AMATS: Seward Highway to Glenn Highway Connection
 Planning & Environmental Linkage Study
 State Project No.: CFHWY00550
 Federal Project No.: 0001653

Alternatives Refinement and Initial Screening Report

Final

July 2025

Figure 8. Parkway Alternative D

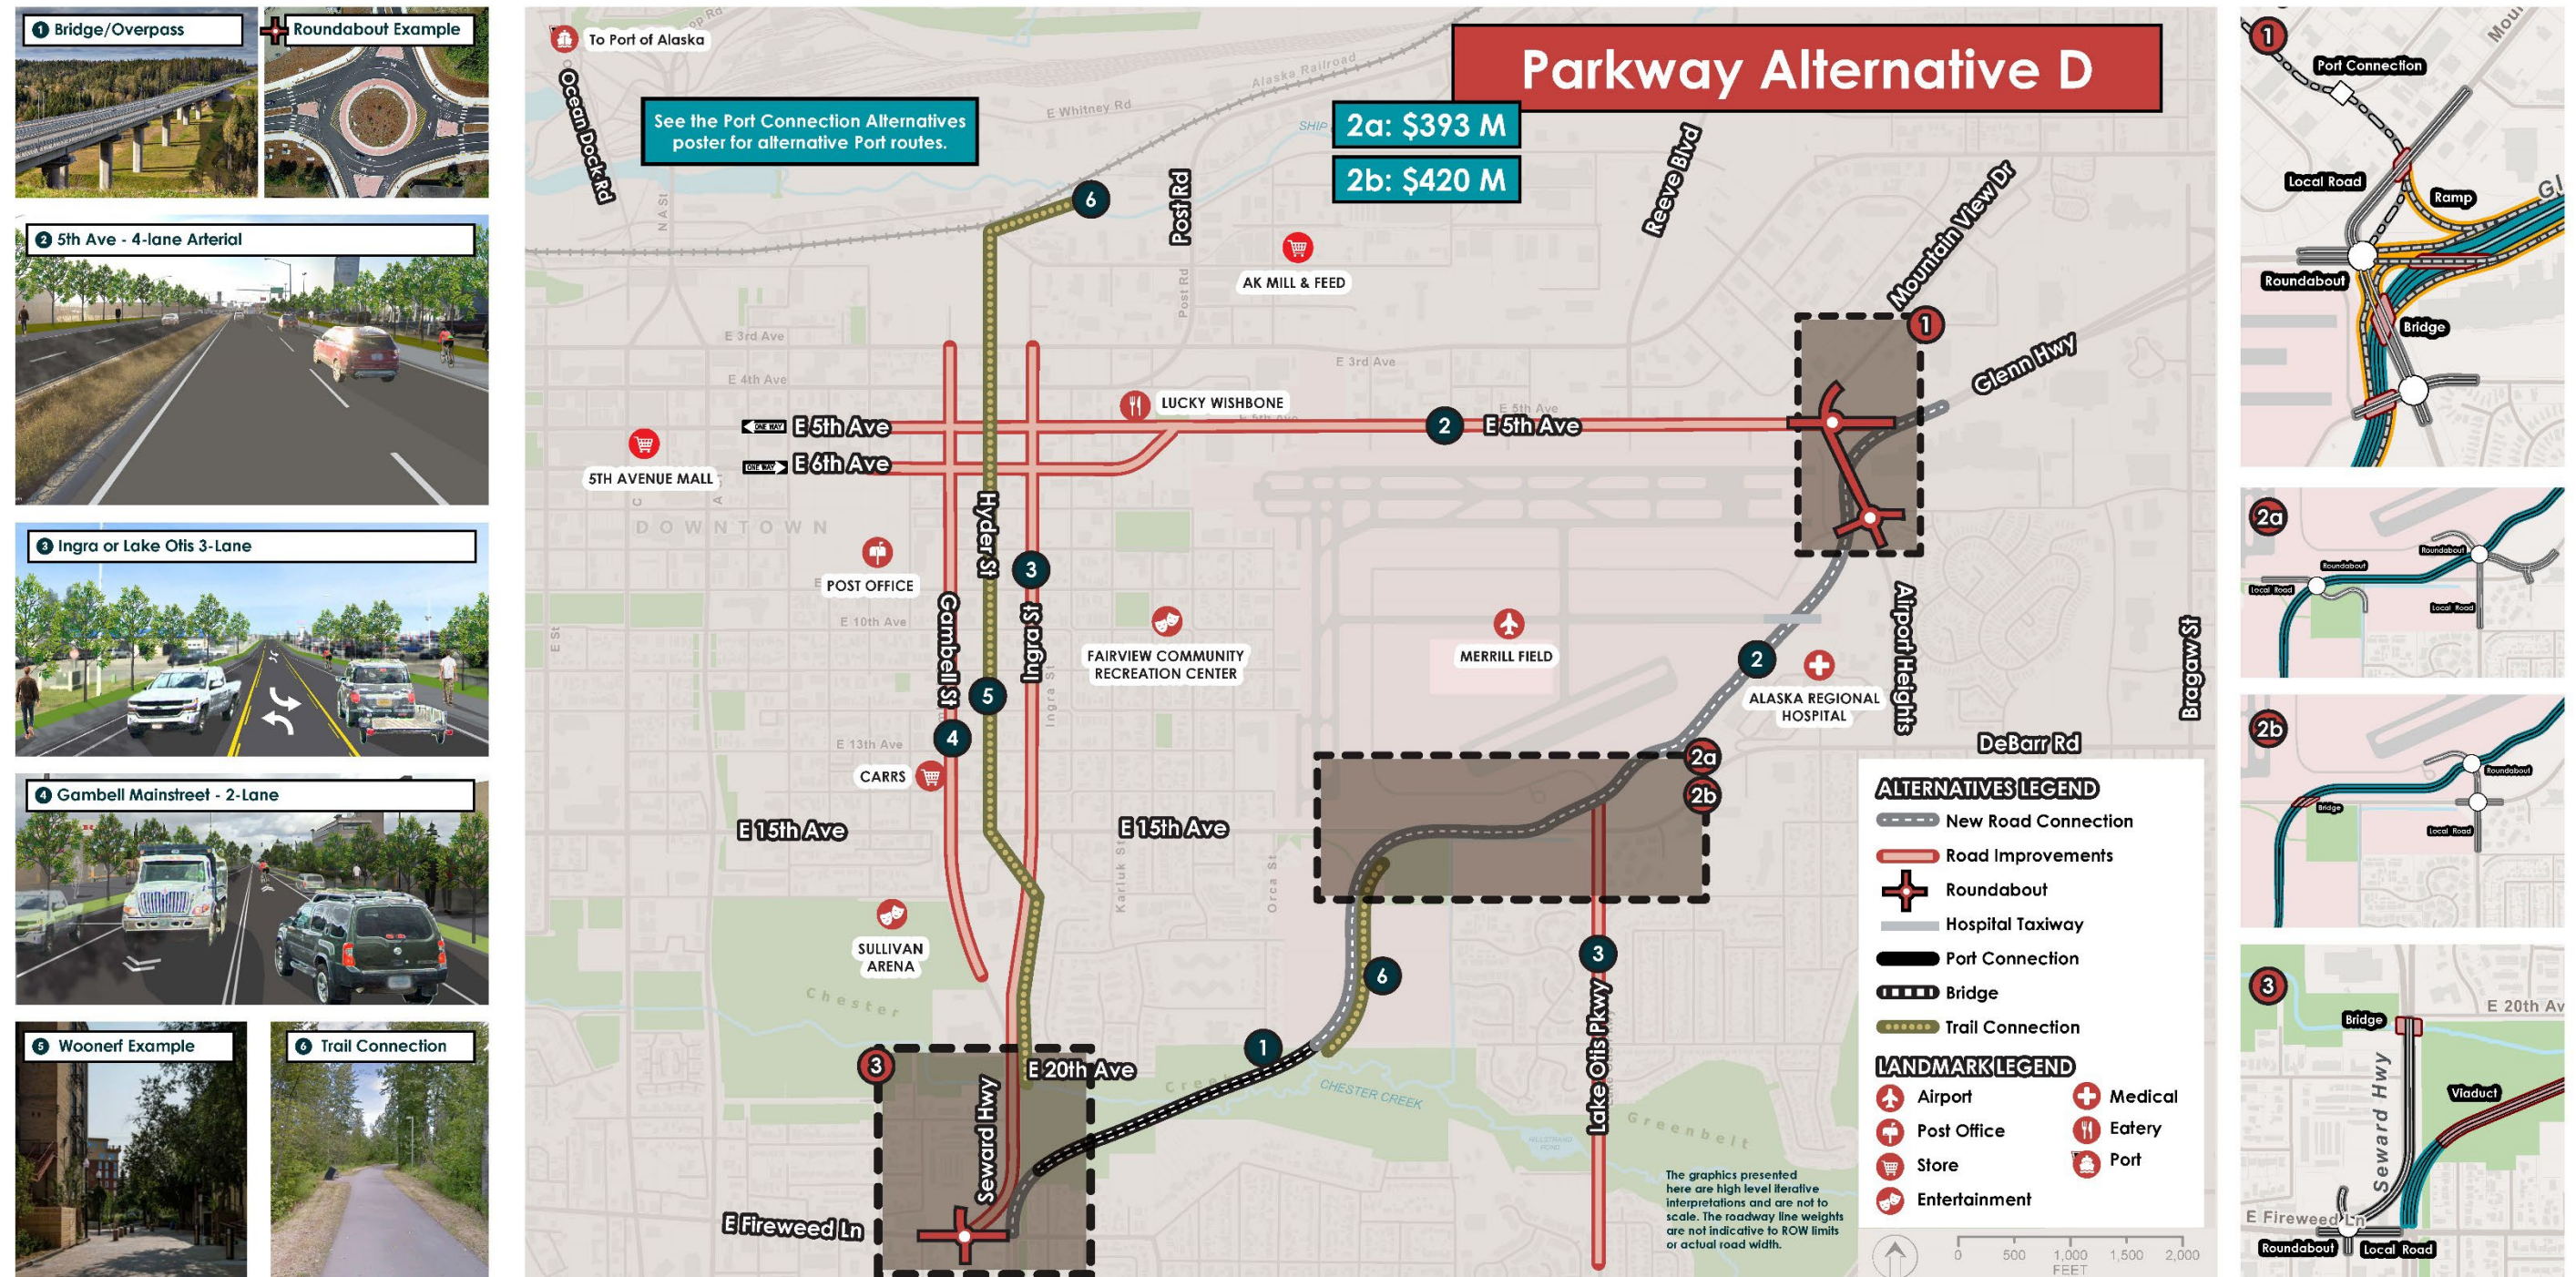
The illustration of a one-span bridge (Figure 8, Parkway Alternative D) is inadequate to give the public an idea of an approximately 3,000-foot-long viaduct.

Parkway Alternative D has been screened out from further consideration due to park and other impacts.

Figure 11. Section 4(f) and 6(f) Resources within the Study Area

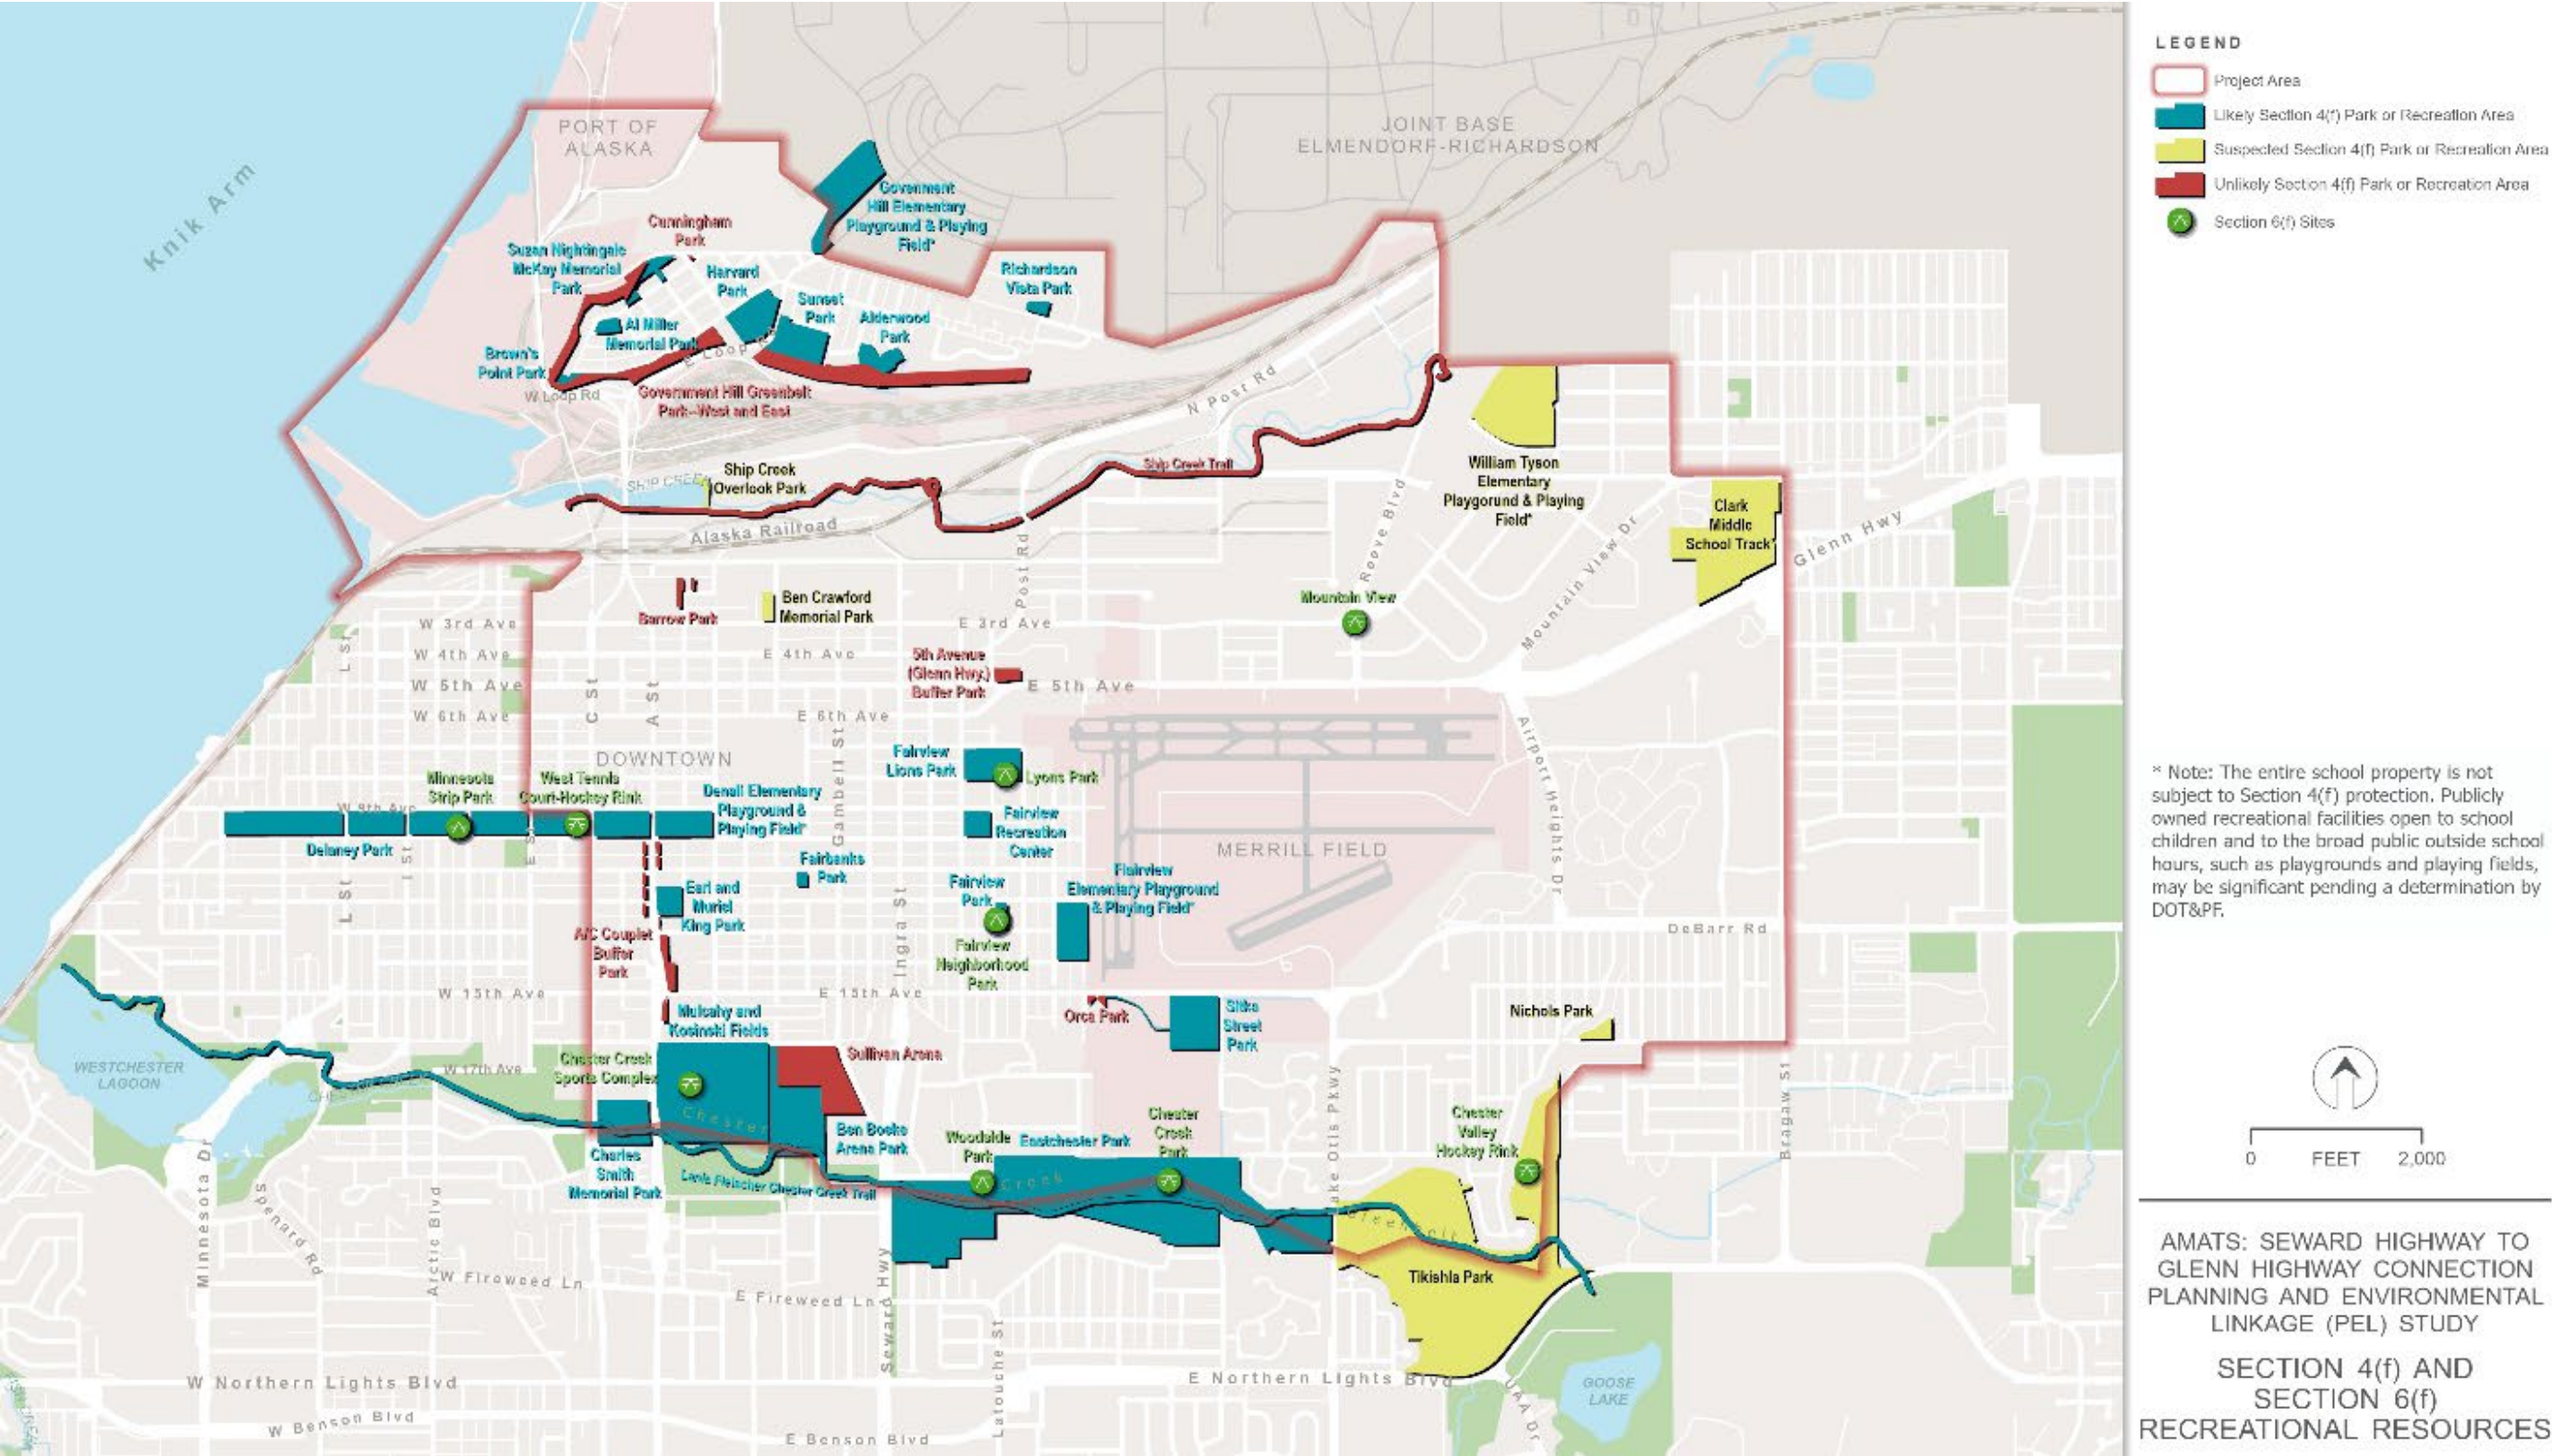
Further, when comparing the alignments of Alternative D (freeway and parkway); the narrative descriptions of these routes; and the map of Section 4(f) and 6(f) resources (p. 27, figure 11), it is not evident how the tallies of "Parks Impacted" are made. Parkway Alternative D is credited with impacting five parks. The map suggests there are four: Eastchester Park, Woodside Park, Chester Creek Park, and Sitka Street Park. Freeway Alternative D (which the narrative points out has greater impacts to Woodside and Sitka Street Parks) is credited with impacting two fewer parks.

Figure 4. Comments by Alternative

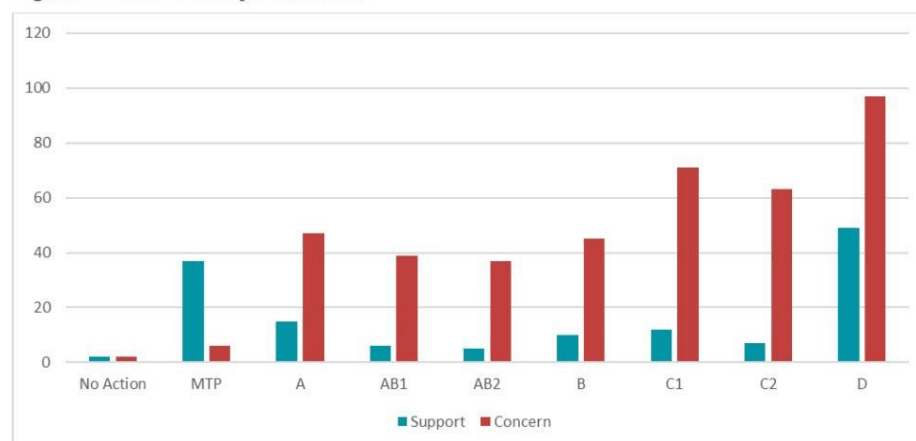
*All together, this gives me the impression that the data have been selectively presented, or even intentionally misrepresented, to manufacture an appearance of public support for Alternative D. I hope it was simply an error or miscommunication instead."*¹
